ANDALEX
RESOURCES, INC.

Re: Andalex Resources, Inc. C/007/019
T17-001 Removal of Monitoring Points Task ID# 5440

Attached you will find changes made to MRP C/007/019, Tower Mine regarding the Removal of Water Monitoring Points. Due to the release of the Kenilworth lease in July of 2016, monitoring of these points is no longer needed.

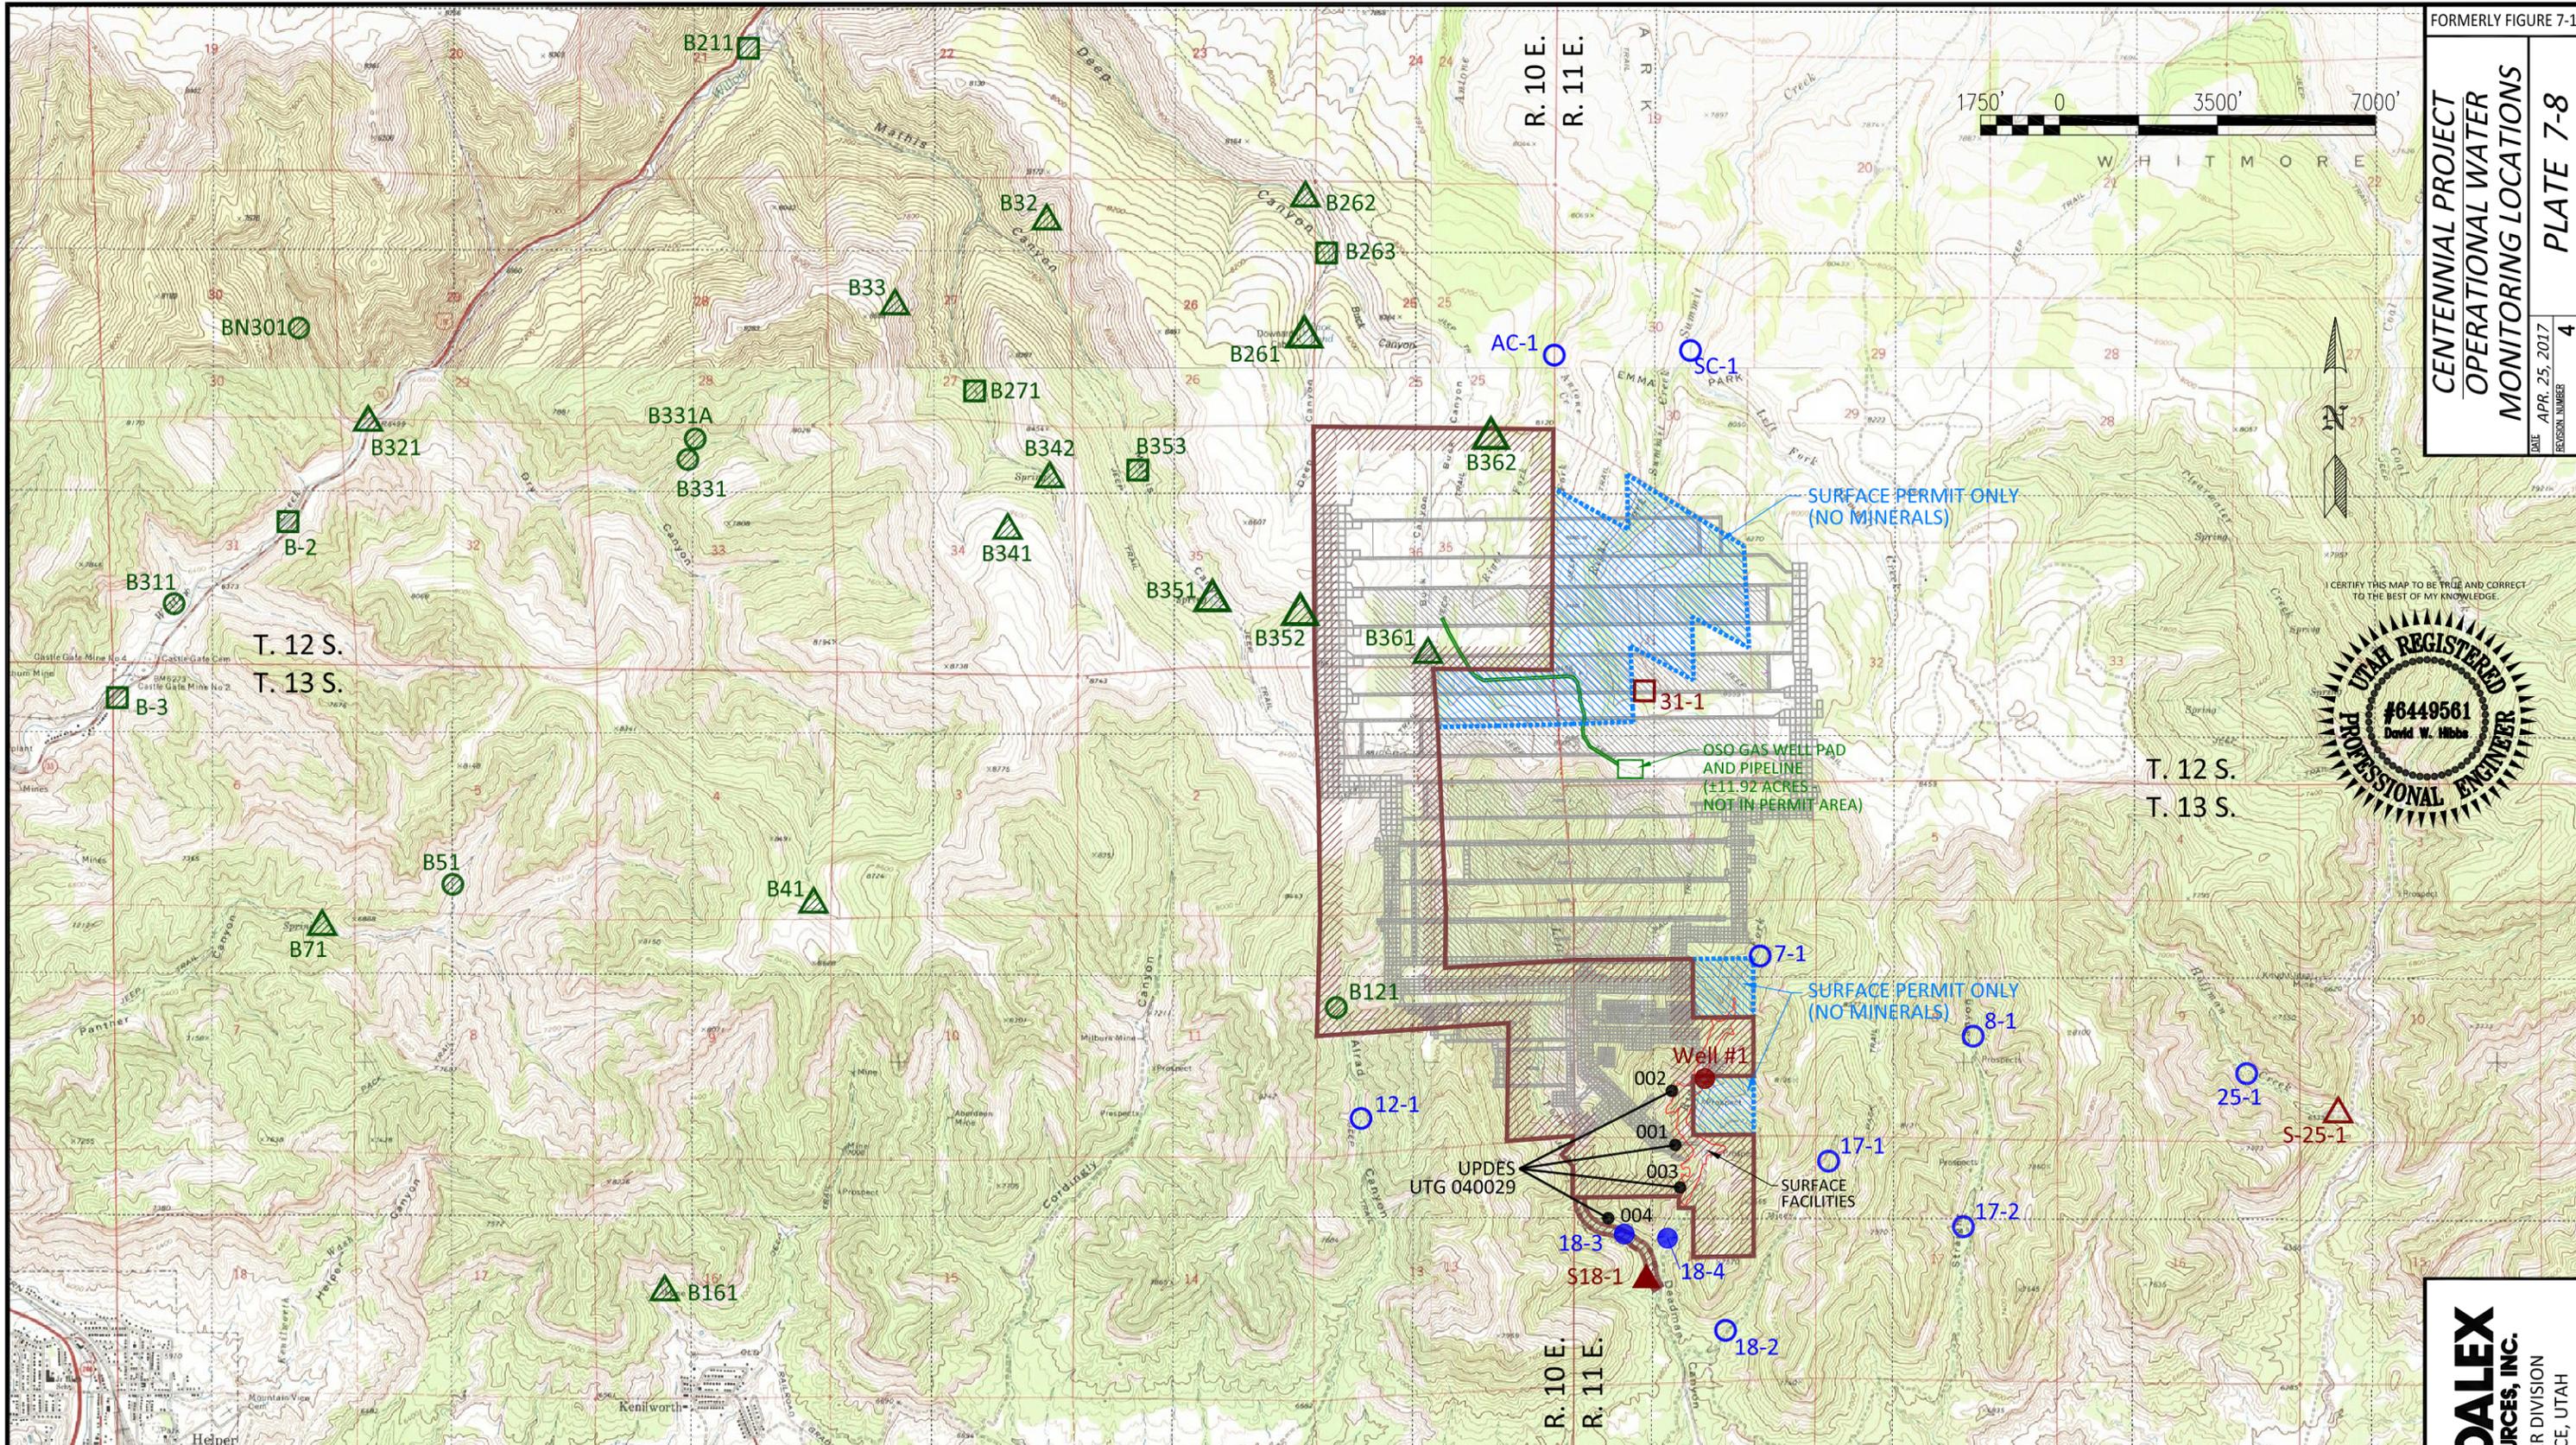
In addition, there are numerous sites to the north and west of the permit area which have been omitted from this plan. As shown on Figure 7-1Plate 7-8, a well monitoring station (B121), and stream site B263 is, B263, and B262 are located more than a mile away from the nearest underground mining, and stream sites AC-1 and SC-1 are three-quarters of a mile from the closest mine works. FourOther spring or seep sites (B 342, B271, B33, B361, B353, B341, B351, B352, B261, and B362) are similarly located well away from any recent mining. It should also be noted that at these sites the overburden is 3000' deep or greater. All mining in the Aberdeen Mine (Tower Mine) was discontinued in mid-2007, the mine has been shut down and sealed up, and there are not immediate plans to ever reopen the mine in the foreseeable future, until market conditions improve.— Therefore, there is no continued need for monitoring.

Last, one other stream site and one stock pond site within the permit area is also being omitted from the monitoring plan. Ephemeral wash site 7-1 is located upstream of the main surface facilities and is typically dry. Because site 18-4 monitors the same stream further downstream and because operations have ceased, 18-4 is sufficient for tracking potential impacts in this drainage. Site 7-1 was never undermined, and the nearest second-mining (nearly one-half mile away) was completed in 1998. The stock pond site 31-1 is located over a inter-panel barrier pillar and was never undermined. The nearest second mining was done in 2004. Overburden cover at this location is 2500' and subsidence survey show that the area has not been subject to subsidence
